HISTORIC LANDMARK COMMISSION
PERMITS IN NATIONAL REGISTER HISTORIC DISTRICTS
AUGUST 27, 2012
NRD-2012-0093
416 E. 6th Street
Sixth Street

PROPOSAL

Install a new metal guardrail at the parapet to extend the roof deck.

Cheers deck extension

Picture 1 - HVAC on roof
Existing

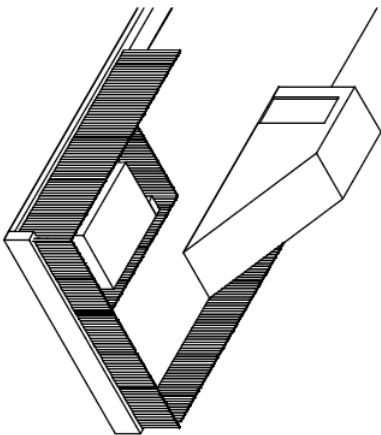
The building currently has a roof deck; the wooden guard wall is currently approximately 10 feet back from the front parapet. A large air conditioning unit occupies the left front corner of the roof. The applicant proposes to help hide the air conditioner by constructing a painted metal guardrail at the parapet line, which will extend the roof-top deck by approximately 200 square feet.

Staff recommends approval of the application, even though the project violates several tenets of the Sixth Street Architectural Design Guidelines. The rooftop air conditioning unit has been in place for a long time, and the applicant explored ways to hide or move the air conditioning unit but found no way to do so given the restraints of the building and its mechanical systems. Faced with an unfortunate situation with the location and visibility of the mechanical unit on the roof, staff must agree with the applicant that it cannot be remedied in and of itself, and that the proposed railing will help screen the unit from view.
